ERIE PARKWAY AND WCR5

EVERGREEN DEVELOPMENT

**RE: Erie Highlands Filing 17 – Overall Site Plan
WCR 5 & Erie Parkway (WCR 8)
Comment Responses**

Re: SP2025-00002, Erie Highlands F17 Site Plan

OVERALL SITE PLAN

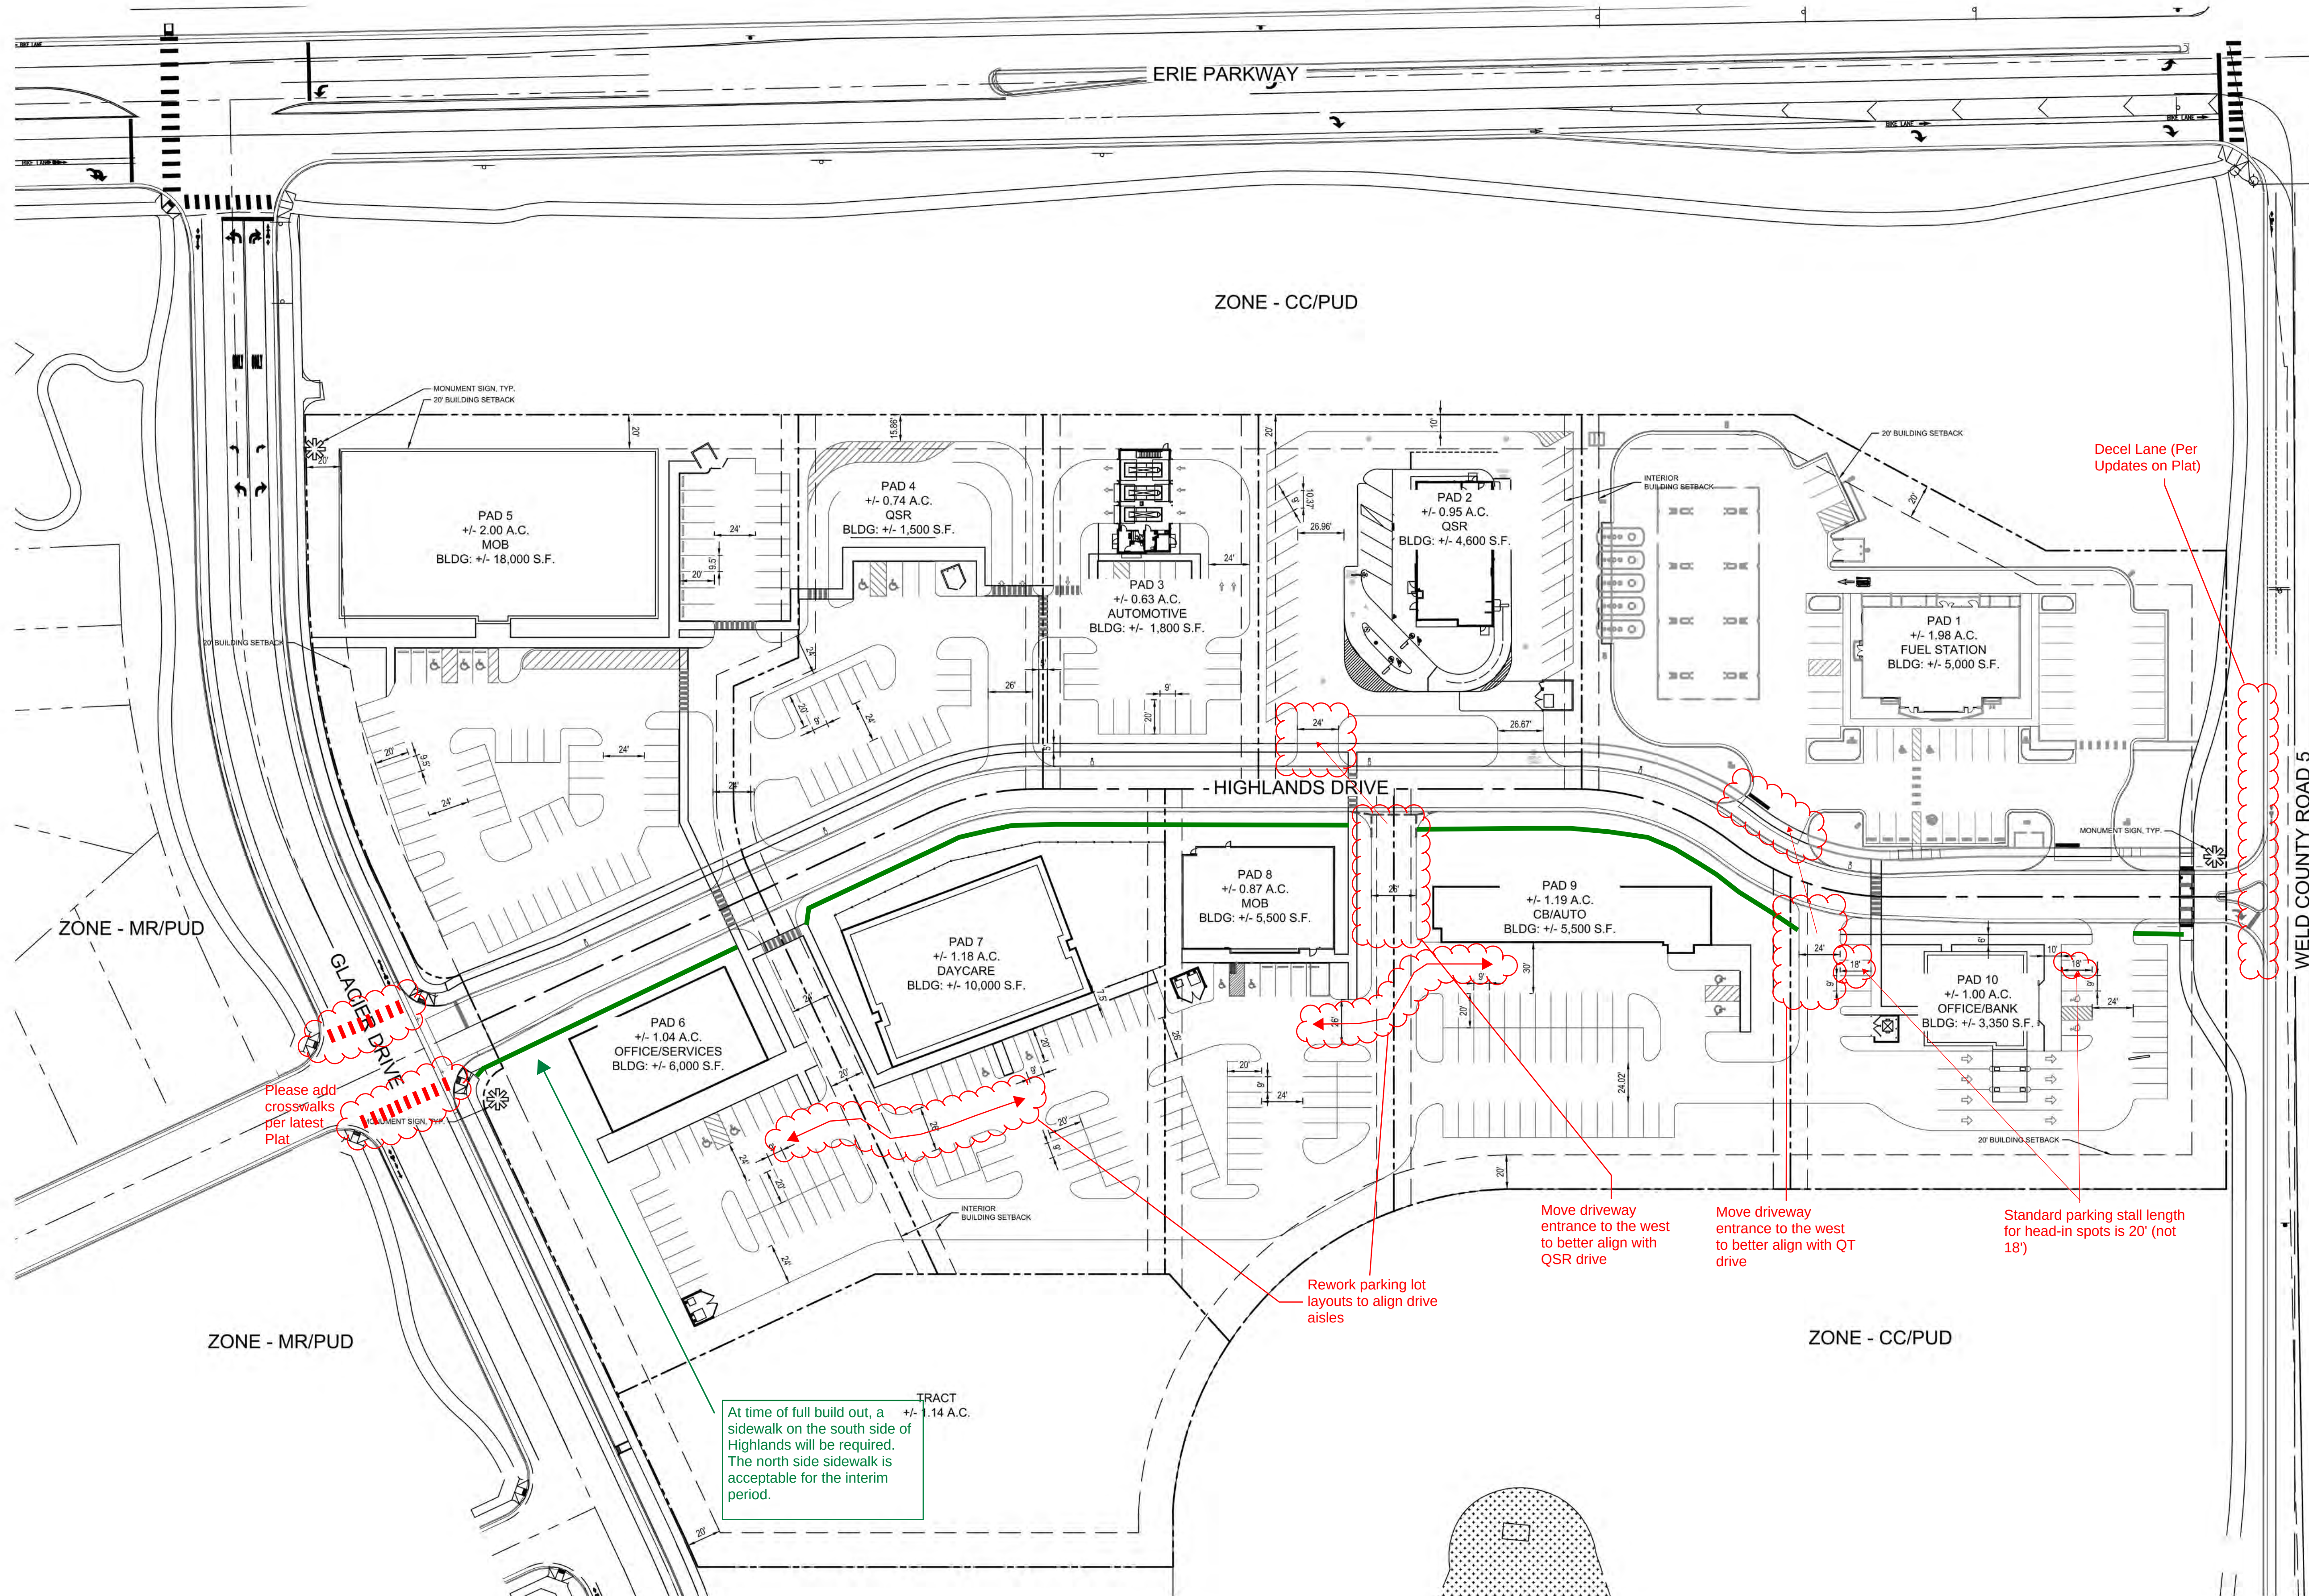
It would be helpful to have lot by lot and total parking counts just for reference, even though we know they could change with individual users coming in.

Landscaping (and otherwise) maintenance -- by the metro district? any plan for business association? Our preference would be to not have it lot by lot

Trash enclosures - share between adjacent lots the extent feasible, to help consolidate and minimize the numbers of trash enclosures.

Response: Comment has been addressed. Please see parking counts provided per pad.

Response: Noted. Evergreen is planning to address this in a COREA that will detail maintenance responsibilities.

Response: Noted. Discussions will be needed during individual site plan reviews. The Overall Site Plan is still conceptual, and all end users have not been identified. Opportunities to consolidate are yet to be identified.

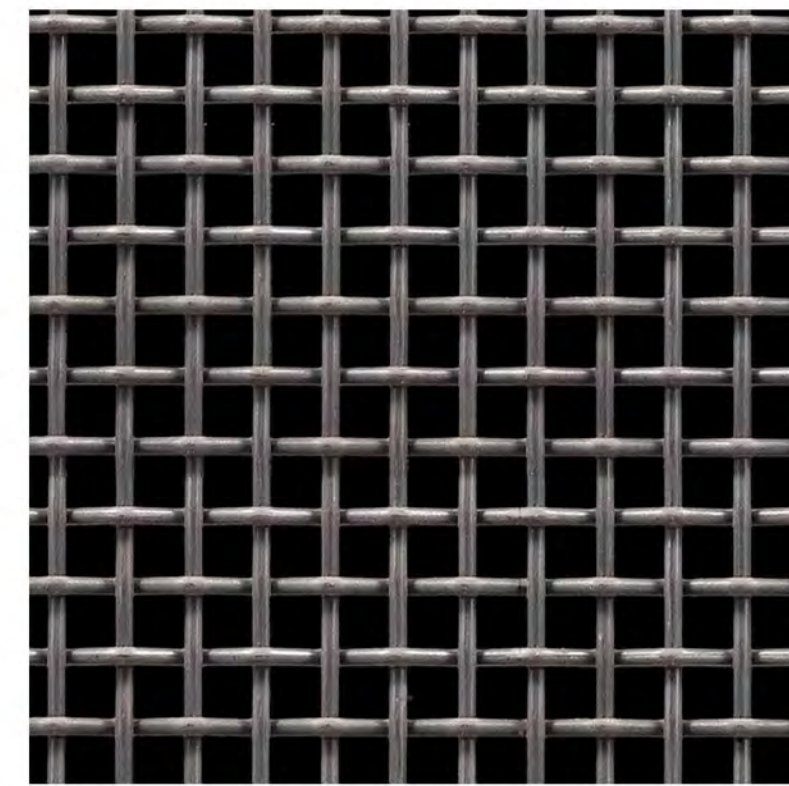
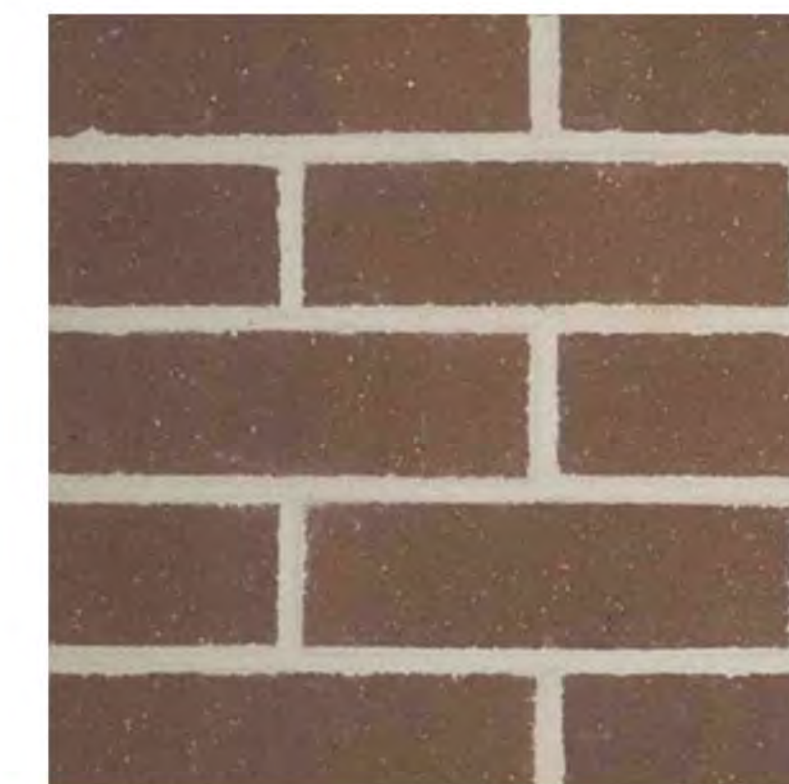
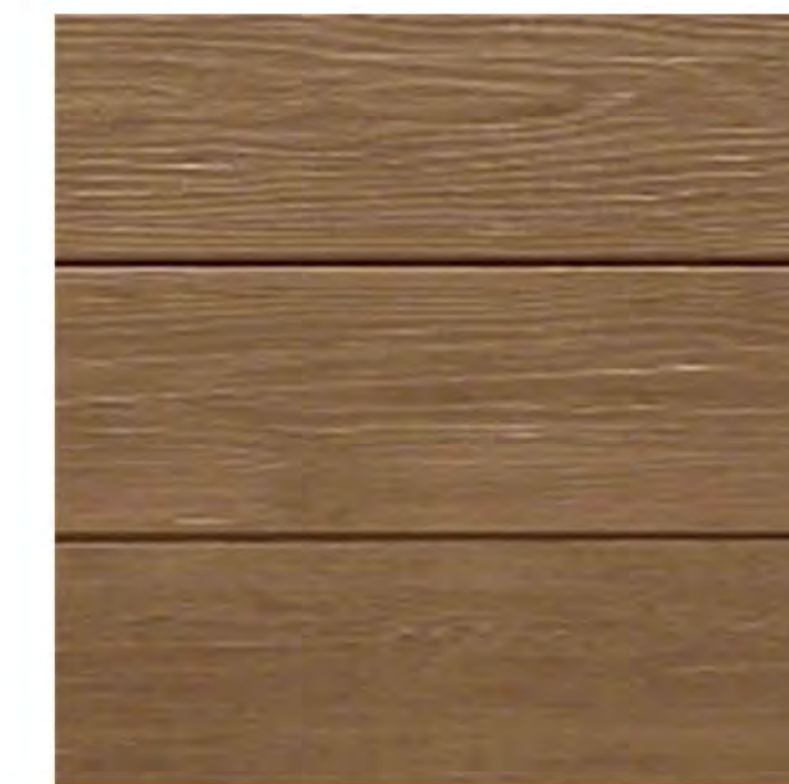
Please limit the use of EIFS to accent materials, while utilizing masonry and siding as primary materials, in order to be consistent with Comp Plan's designation of this area as an "Area of Special Consideration"

Response: Comment has been addressed. The Building Materiality Plan has been updated with additional colors for the cementitious fiber material, a note stating "Masonry, fiber cement and materials shall be used as primary materials. The use of EFIS shall be limited to an accent material" has been added.

APRIL 23, 2025 COMMENTS

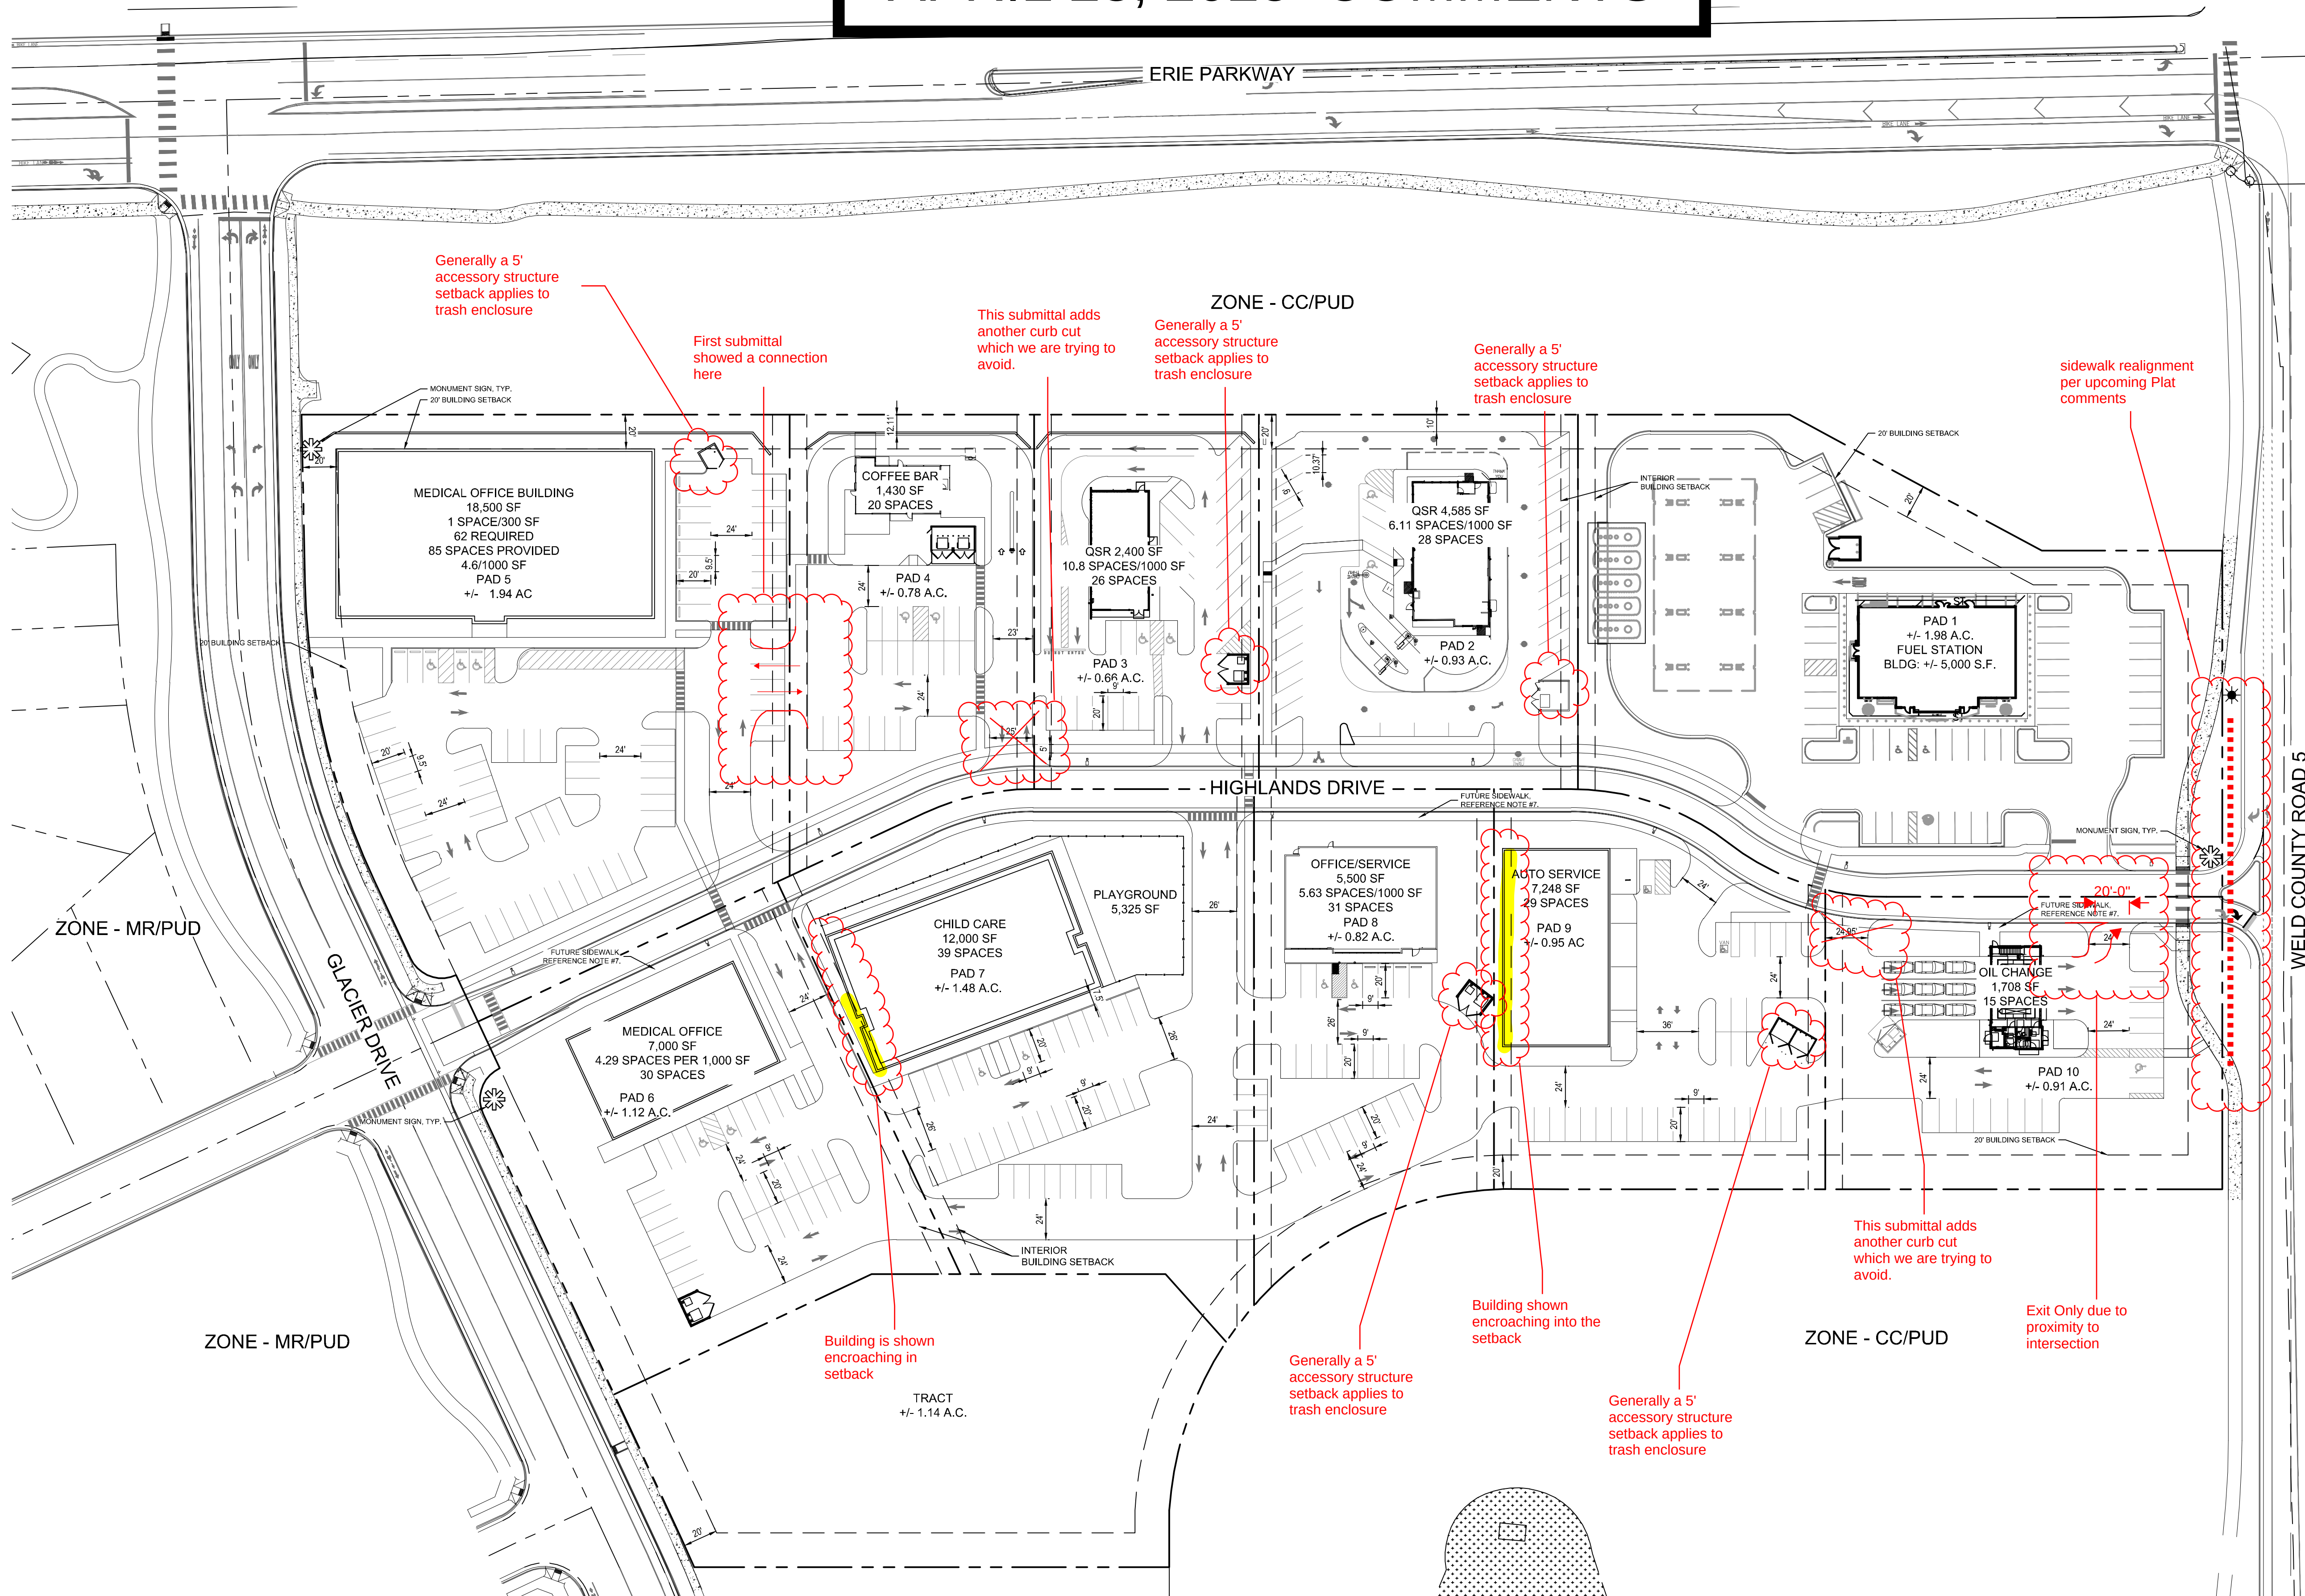
- APPROVAL OF THIS SITE PLAN IDENTIFIES ~~THE ALLOWED USES~~ AND GENERAL CONTEXT FOR PAD SITES WITHIN THE OVERALL DEVELOPMENT. PAD SITE DEVELOPMENT CONFORMING WITH ~~THE APPROVED USES AND~~ DISTRICT STANDARDS NOTED HEREIN CAN BE APPROVED ADMINISTRATIVELY THROUGH THE TOWN SITE DEVELOPMENT PLAN PROCESS.

1. Suggested edits to Note 1
Response: Comments have been incorporated and Note 1 has been updated to reflect suggested changes.
